**Harbourside Shopping Centre Redevelopment SSD-7874  
Amended Concept Proposal and Stage 1 Early Works October 2020 and  
Response to submissions**

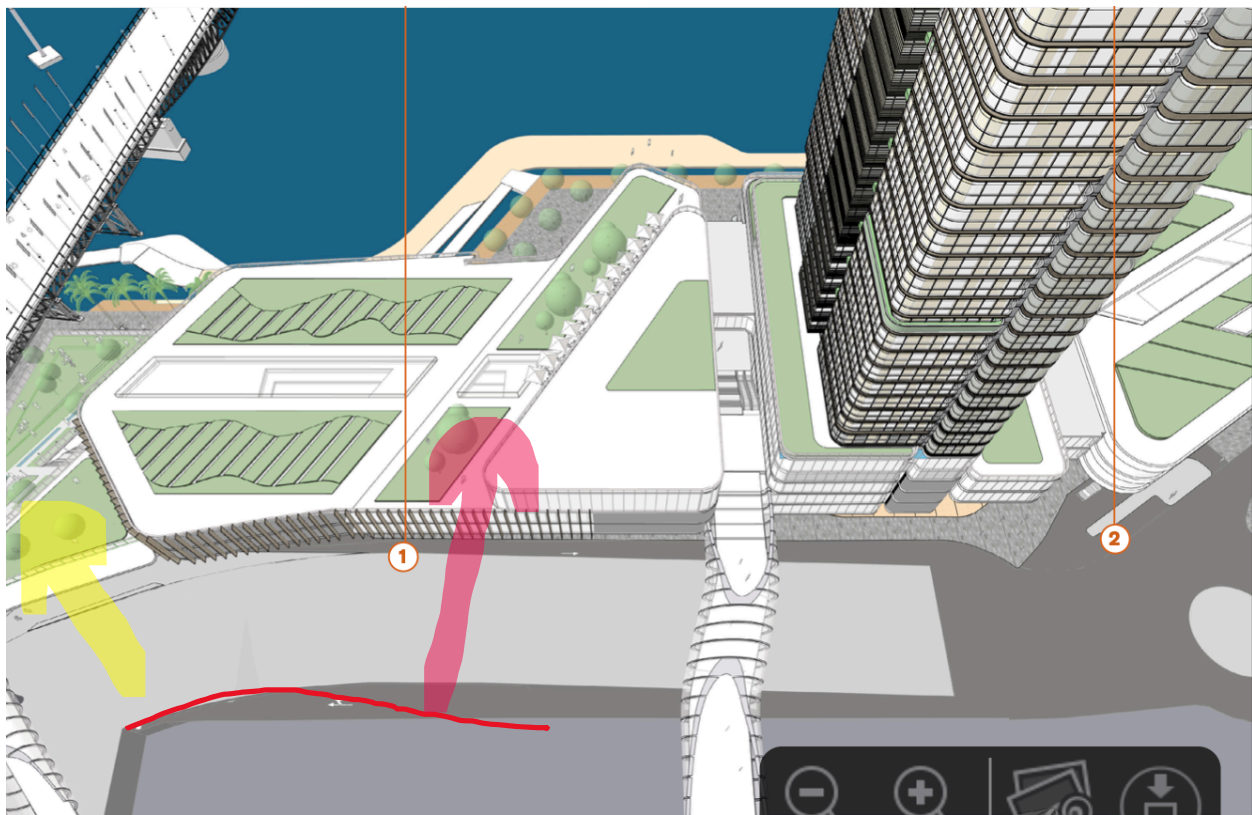
The majority of the **east facing** apartments of 50 Murray Street have highly valued views that enjoy **whole water views of Cockle Bay**. Every aspect (Floor to ceiling glass) of the apartments, in addition to the balcony, have a view of the water. With the previous concept, all east facing apartments at level 8 and below totally lost all Cockle Bay views. The amended concept as shown below still has east facing apartments losing all Cockle Bay water views.

The proponent claims that by introducing a north east facing 'channel' it provides views north of Pyrmont Bridge and thus claims it has '*significant improved view sharing of 50 Murray Street*'. This is an **unacceptable claim**. It has been pointed out that east faced of 50 Murray Street is a curved. Providing a north east channel at the north end of the proposal has no impact on sharing the water views of Cockle Bay.

*Views from curved 50 Murray Street are inconsistent with the provision of a channel view platform to the north east claiming to have '*significantly improved view sharing of 50 Murray Street*'*

### ***Relationship with Pyrmont Bridge***

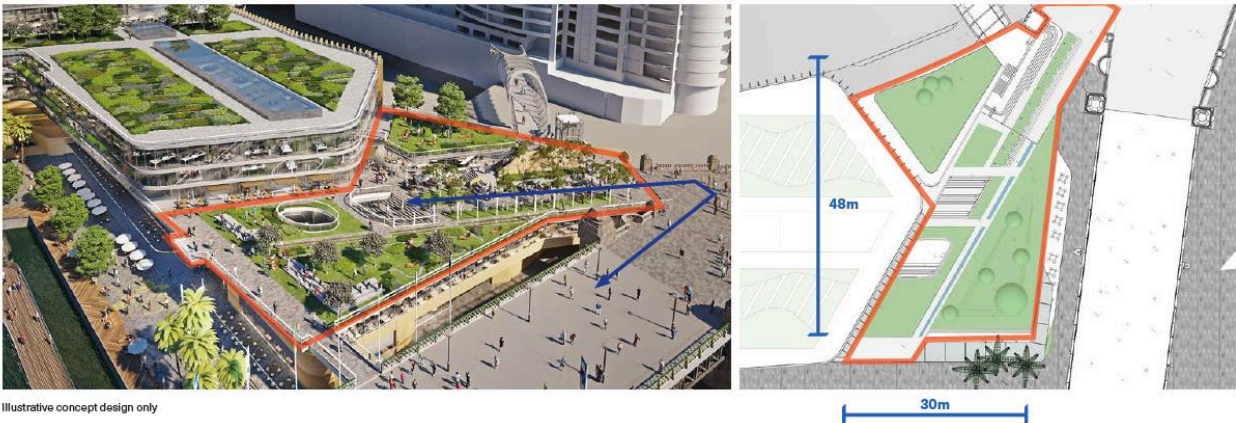
The podium setback to Pyrmont Bridge is only some 25 meters where the RL rises from 13.75 to RL 25 which still significantly overpowers the State listed Pyrmont Bridge. The Cockle Bay side of the Pyrmont Bridge has an RL of 12 for 65 meters.

*RL's of Cockle Bay Wharf Approved Development*

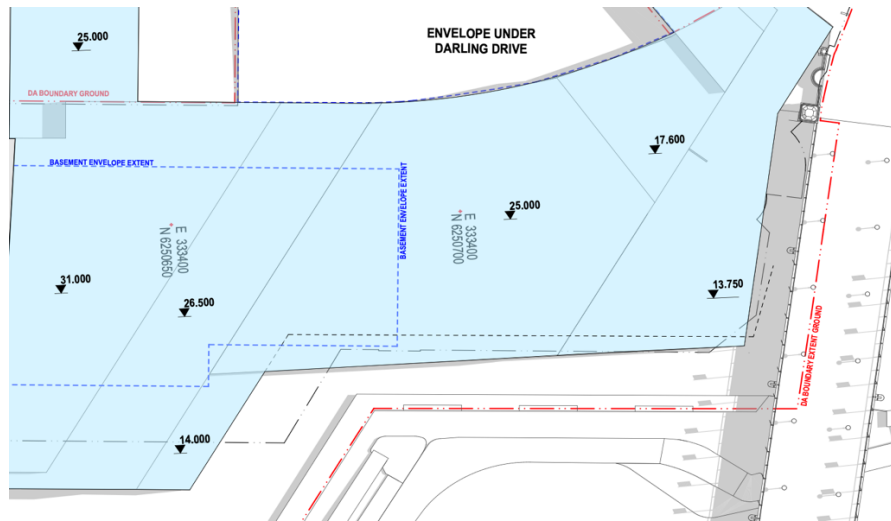
The Cockle Bay Wharf State Significant Development (SDD7684) was approved earlier this year. The Department together with the advice from its independent expert design advisor, have given considerable attention to the issue of the Cockle Bay Wharf development on the visual impact on Pymont Bridge and Darling Harbour more broadly. The north podium (closest to Pymont Bridge) has an approved RL of 12 at the harbour's edge and RL of 19 over the road providing a on level park some 95m wide. This two-level podium extends for 95m away from Pymont Bridge before increasing to RL 29 which is only 7.9m before the tower commences.

In contrast, the Harbourside Shopping Centre Redevelopment proposal is for a two-level park RL's of 13.75 and RL 17.6 extending away from the Pymont Bridge by only some 30m before rising to 25, proposing and RL of for the northern portion of the podium rising to RL 26.5 and then RL31.

The impact of approving the envelop for the Harbourside Shopping Centre Redevelopment will produce two inconsistent character of addressing the Cockle Bay basin as well as an inconsistent start and end of the Pymont Bridge.
